TECHNICAL EVALUATION REPORT

DAVIS-BESSE NUCLEAR POWER STATION UNIT 1

Alternate to Keylock
Control to Bypass Valves

Docket Number 50-346

DHR SUCTION LINE DIAGRAM

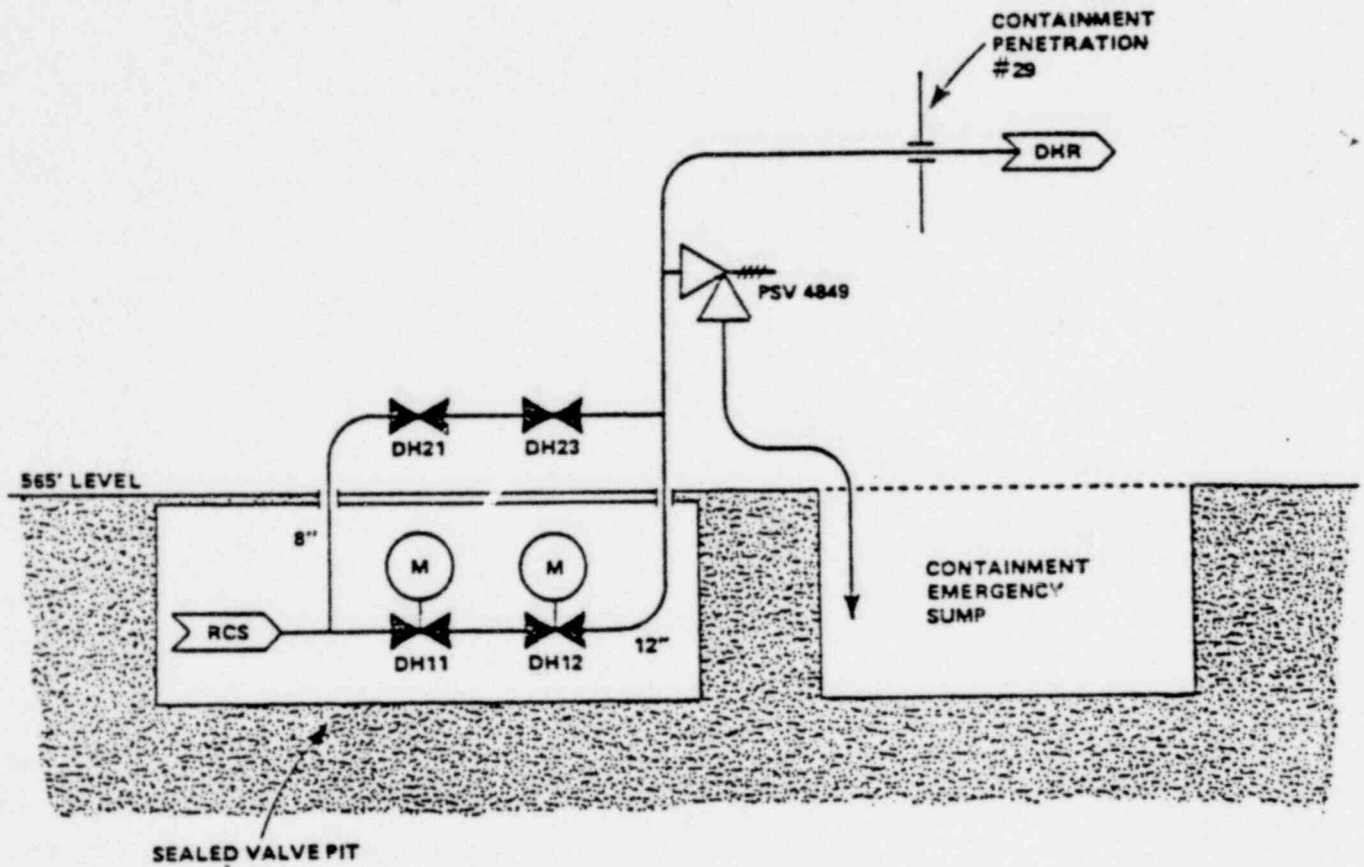
of the bypass path being opened inadvertently when isolation of the DHR loop is required. (See diagram.) The submitted analysis and installation of approved design modifications shall be completed prior to startup following the first scheduled refueling outage.

The bypass loop contains two manually operated valves around the DHR suction line valves. The normally closed bypass valves would be opened in the event of a spurious closure of one of the DHR system suction line isolation valves during system operation. NRC requires that further attention be given to the means employed for isolation of the low pressure residual heat removal system from the primary system while the latter is pressurized, and that reliable means be developed to assure such isolation. Present procedures have a chain and padlock. The key opens no other valves, but does open certain restricted area doors. The two manual isolation valves are in series on the bypass line.

meet the criterion associated with shutdown when the risk is much reduced. In order to improve safety and meet the inferred acceptance criterion without question, Toledo Edison is prepared to implement procedural option 3 entailing the use of one unique key and lock to secure the bypass valves.

The Toledo Edison technical report fulfills the NRC Safety Evaluation Requirements (April 1977) for the analysis of design modification alternatives for the present key lock control of the manual bypass valves DH21 and DH23. The proposed procedural change entailing the use of one unique key and lock to secure bypass valves decreases the likelihood of the bypass being opened inadvertently when isolation of the DHR loop is required. This unique key and lock procedure will be implemented prior to startup following the first regularly scheduled refueling outage. NRC Safety Evaluation Report (April 1977) requirements are being met. Therefore, I see nothing technically wrong with the alternative to the key lock control procedure.
